8. Well Name and No.
JAMES RANCH UNIT D12 191H

XTO Permian Operating, LLP (XTOPO) respectfully submits this sundry notice for change in the Onshore Order variance submitted for James Ranch Unit D12 Battery (EC 458437).

JAMES RANCH UNIT D12 CENTRAL TANK BATTERY EDDY COUNTY, NEW MEXICO
	SITE FLOW FACILITY DIAGRAM

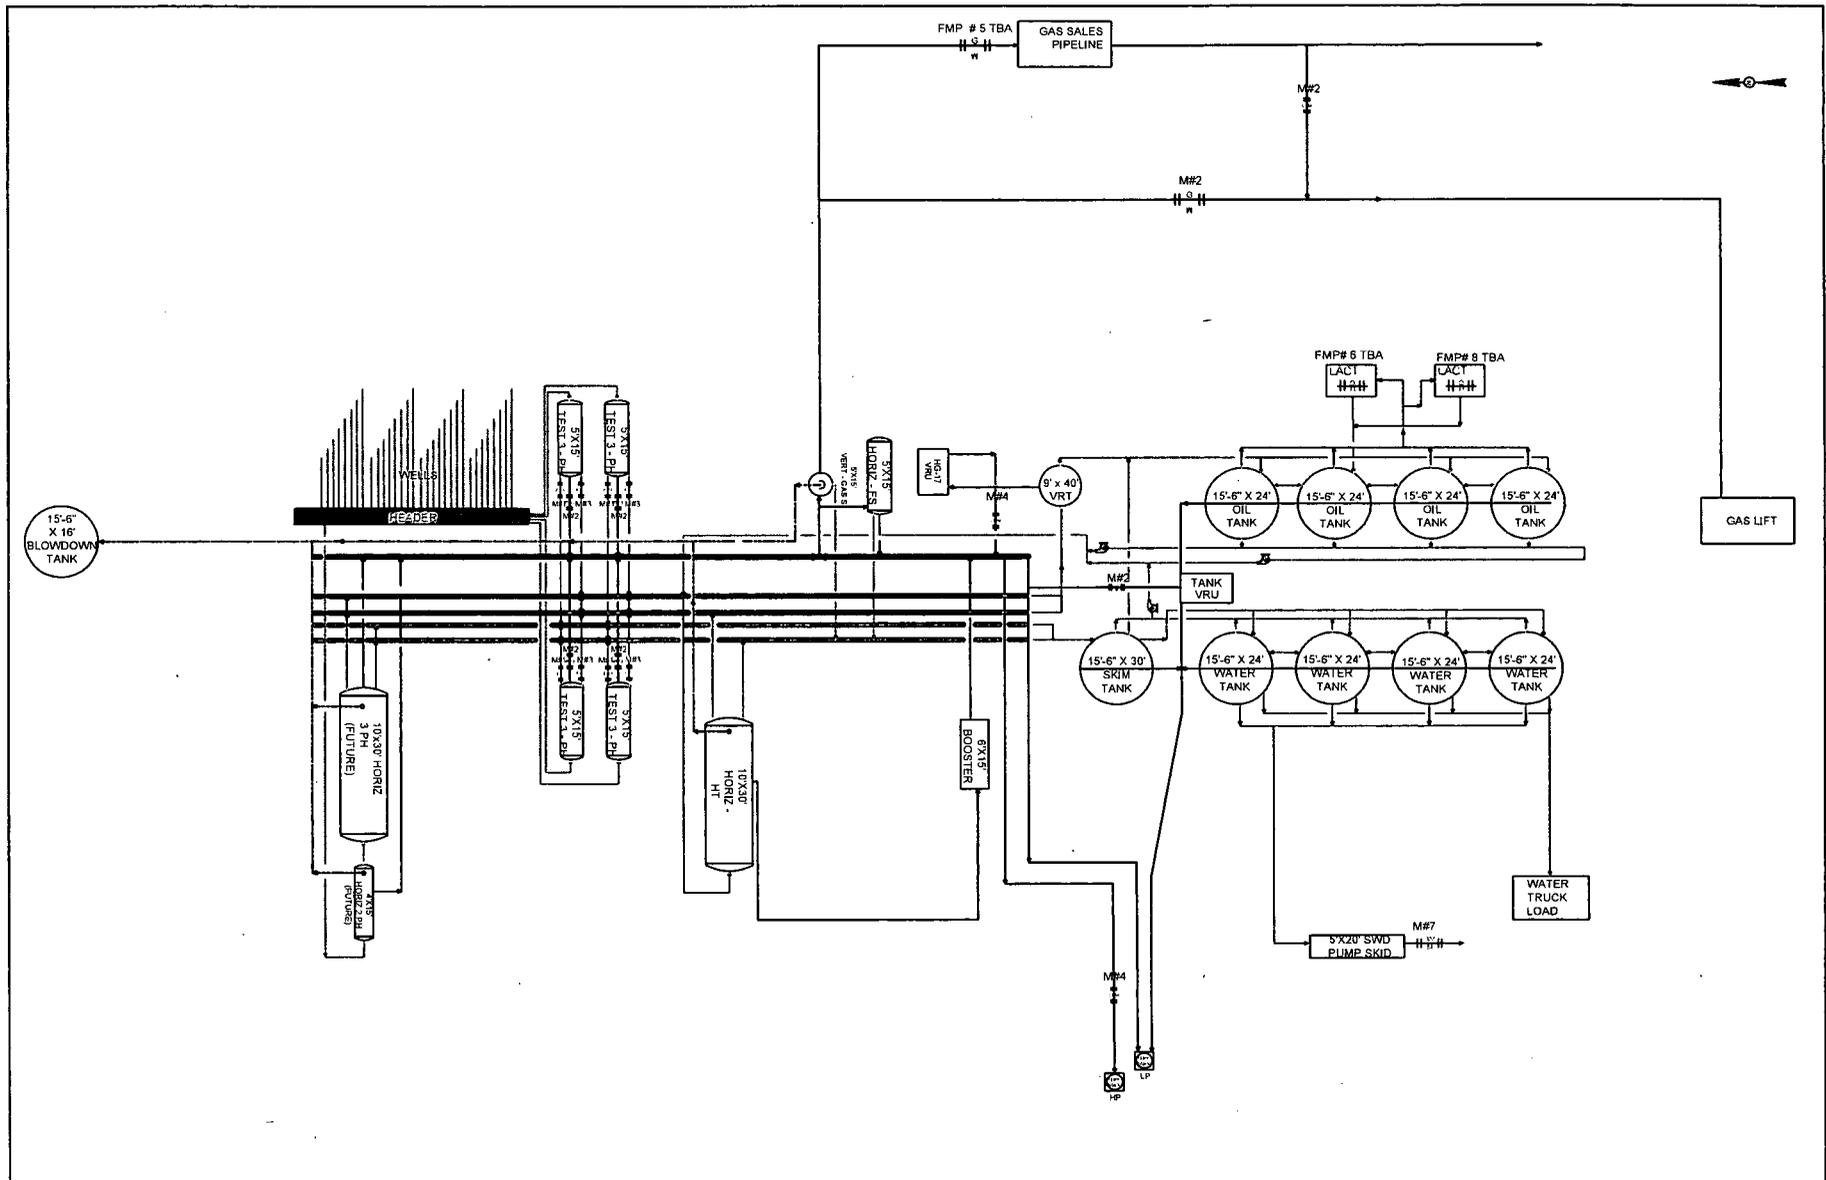
Due to the current production rates of the wells producing to the battery, a second LACT unit is needed to transport oil from the tanks into the pipeline. This second unit will be a second FMP for the facility; both units will be operating simultaneously.

The additional unit will be a Coriolis metering system, installed and proven per 43 CFR 3174. BLM will be contacted prior to proving.

Updated facility diagram is attached.
